PLANNING COMMISSION MEETING AGENDA

SUBJECT: **Site Plan Review #7 – Jack Livingstone, Tree Fellers Wood Products & Furniture
2017 North Burdick**

DATE: September 26, 2023

SUBJECT: **Site Plan Review #6 – Jack Livingstone, Tree Fellers Wood Products & Furniture 2017 North Burdick**

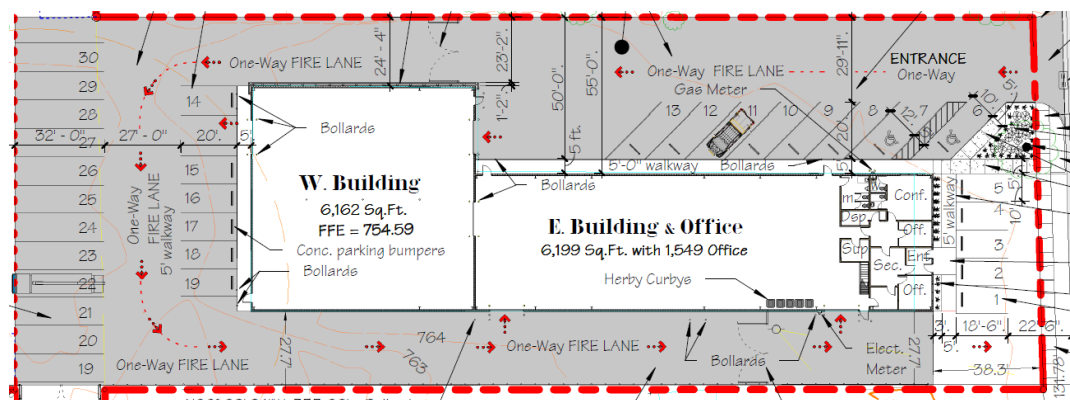
Section 4.01.E.2.c. requires “a 25-foot clear width is required for all fire lanes, to be approved by the Township Fire Marshal”.

The northern portion of the site, shown right **does not meet this requirement.** The applicant has been informed on multiple occasions that a minimum of 26 feet is required for fire lane access. The applicant’s site plan continues to not meet this standard. Note: the fire code, being more restrictive, shall apply in this case.

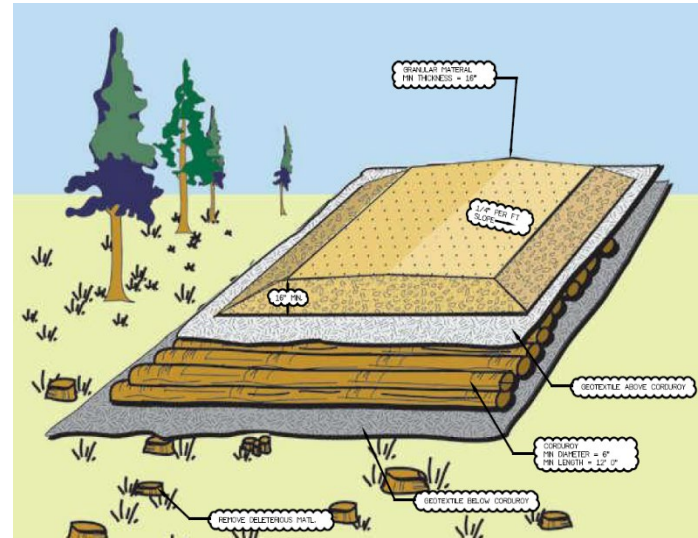
Lastly, the overall site circulation route essentially functions as a private road. The internal access route is intended to serve several landlocked nonconforming parcels that DO NOT have frontage on any public street. Though we understand the applicant is not requesting a land division, Township general ordinance 459.007 states that a parcel cannot be created without required frontage on a public street. No private road or easement access shall be authorized unless the requisite frontage on a public road is also met.

Given all the violations of Township ordinance with regard to site circulation, as well as best practices in planning, zoning, and site design, Township review staff is **not** in support of approving the proposed internal access route.

A-02

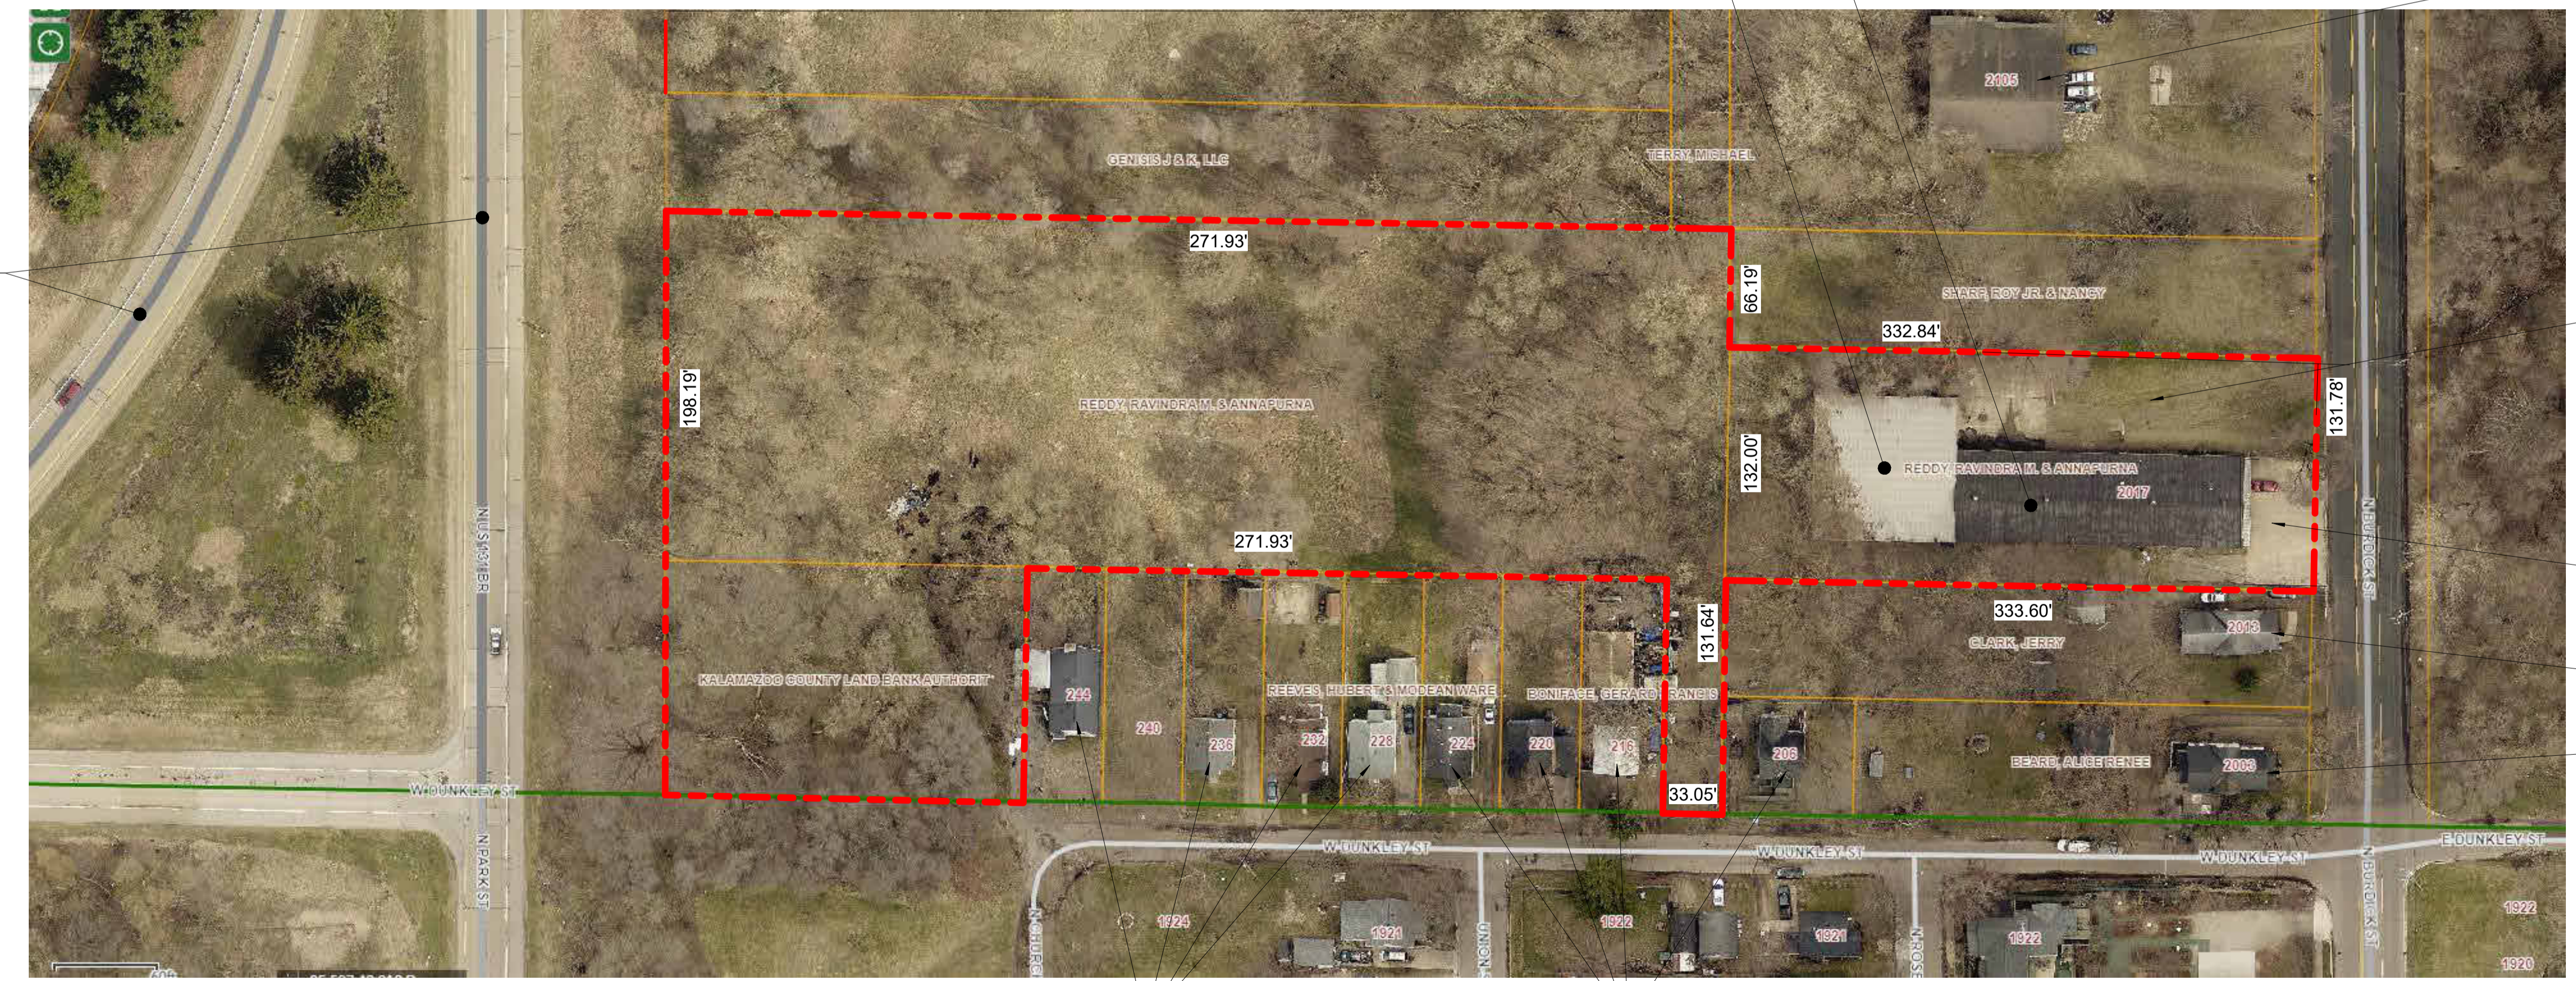
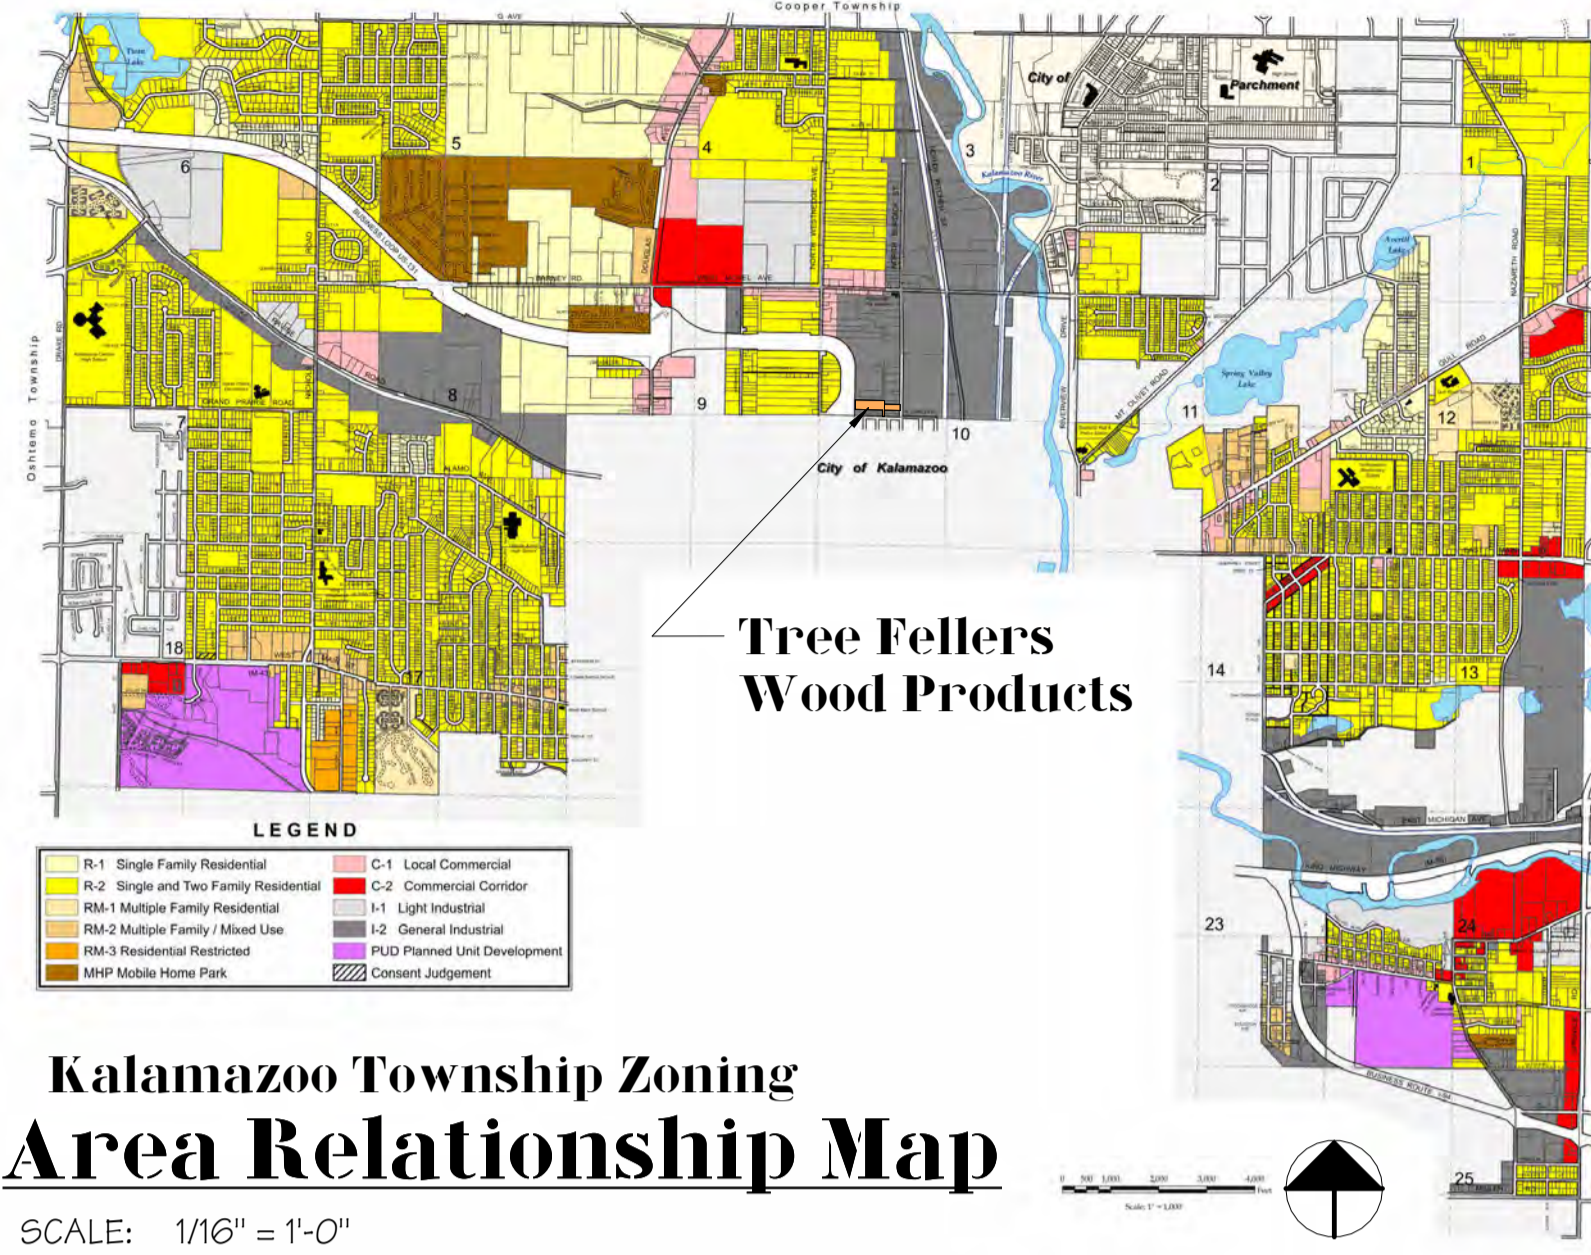
2. Verify all building dimensions and parcel lines.
The proposed site plan does not include an outline surrounding parcel -070, which was apparently included in the lot combination. Parcels -010 and -060 are outlined in red, which clearly designates the site plan area. If parcel -070 is combined with -010 and -060, the outline shall encompass ALL areas to be included in the resulting parcel after the combination. As discussed during the September Planning Commission meeting, each site plan page shall be consistent and accurate. This requirement is not satisfied.

7. Relocate the north side gate.
In comparing the previously submitted site plans (dated July 14, 2023) with the most current set (dated September 21, 2023), it appears the proposed north side gate is in the same location. We defer to the Fire Marshal for confirmation and further comment. **This requirement is not satisfied.**

- The site plans are missing the Architect's seal.
- Sheet A-02 outlines "wood products processing yard" uses on parcel -060, **which should NOT be included in this site plan package.**

- A highway sign is included on the site plan page A-02. All signs with frontage on US-131 shall be subject to approval by MDOT. **The applicant shall show proof that this request was approved and compliant with the Township's sign standards.**
- Drainage details are not provided. Drainage details and design are required. This shall be subject to review by the Township Engineer.
- A 6-foot fence is proposed along the south perimeter of parcel -060 and -010. This could be permitted, provided that the applicant does not conduct ANY business activity on the westernmost parcel.
- Parking calculations are not consistent. Sheet A-02 states 26 spaces and sheet A-02a states 19 spaces.
- According to BS&A, there appears to be delinquent taxes on property -010.

The proposed site plan does not include an outline surrounding parcel -070, which was apparently included in the lot combination. Parcels -010 and -060 are outlined in red, which clearly designates the site plan area. If parcel -070 is combined with -010 and -060, the outline shall encompass ALL areas to be included in the resulting parcel after the combination. As discussed during the September Planning Commission meeting, each site plan page shall be consistent and accurate. **This requirement is not satisfied.**

In comparing the previously submitted site plans (dated July 14, 2023) with the most current set (dated September 21, 2023), it appears the proposed north side gate is in the same location. We defer to the Fire Marshal for confirmation and further comment. **This requirement is not satisfied.**

RESPONSE: Attached is an amended page A-02 from Mr. Schramm that includes the wide red boundary line around parcel 070.

RESPONSE: Page A-02 of Mr. Schramm's plans indicates the required turning radius at the NW and SW corners of the building consistent with the discussions held during the September 7 Planning Commission meeting.

RESPONSE: Page A-02 of the drawings Mr. Schramm hand delivered to the Township office on September 26 indicates relocation of the north side gate consistent with the discussions held during the September 7 Planning Commission meeting.

RESPONSE: Page A-02 of the drawings Mr. Schramm hand delivered to the Township office on September 26 indicates that the guardrail has been removed consistent with the discussions held during the September 7 Planning Commission meeting.

Sheet Number
A-02a

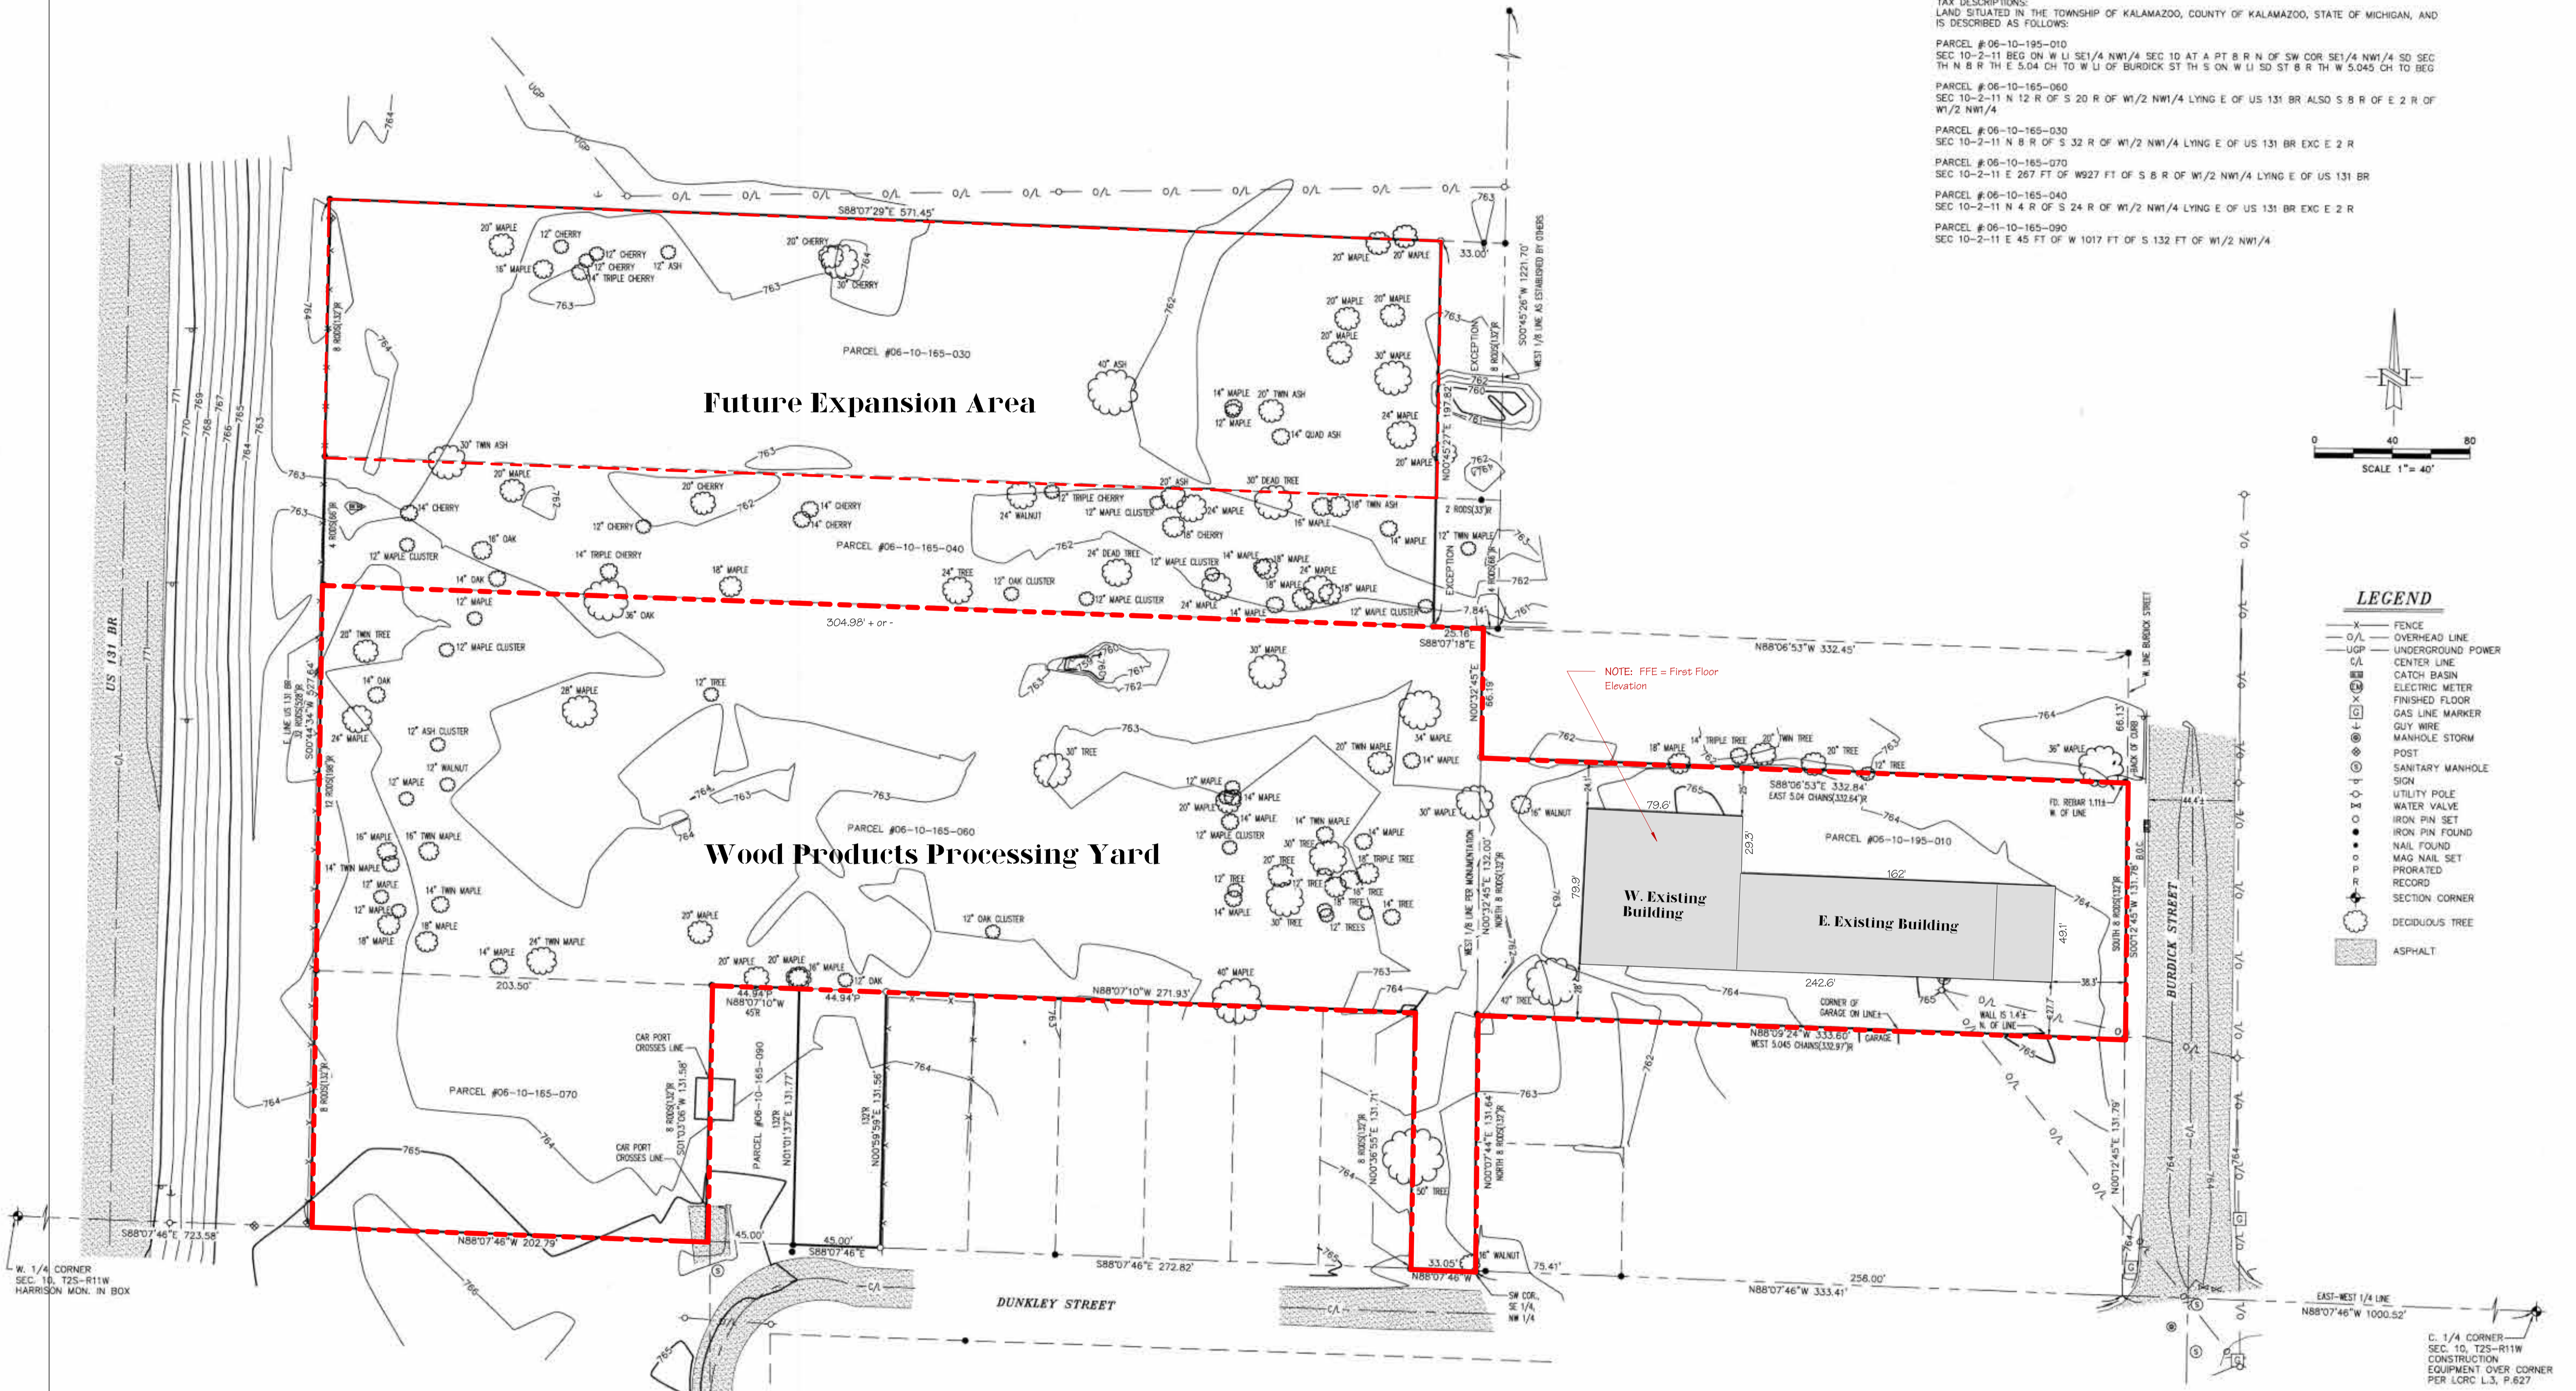
Sheet A-02a notes the proposed use as "wood products yard and woodworking shop." A "Wood products manufacturing, including furniture manufacturing" use is permitted by right in the I-2 District. The site plans shall reflect the proposed use at this time, which DOES NOT include a "wood products yard." **This requirement is not satisfied.**

Sheet A-02a notes the proposed use as "wood products yard and woodworking shop." A "Wood products manufacturing, including furniture manufacturing" use is permitted by right in the I-2 District. The site plans shall reflect the proposed use at this time, which DOES NOT include a "wood products yard." **This requirement is not satisfied.**

RESPONSE: Attached is amended page A-02a indicating the following - "Zoning Use: Current intended use – Office and Administration". Please also note that the attached page A-02a corrects the number of on-site parking spaces from 19 to 26 spaces.
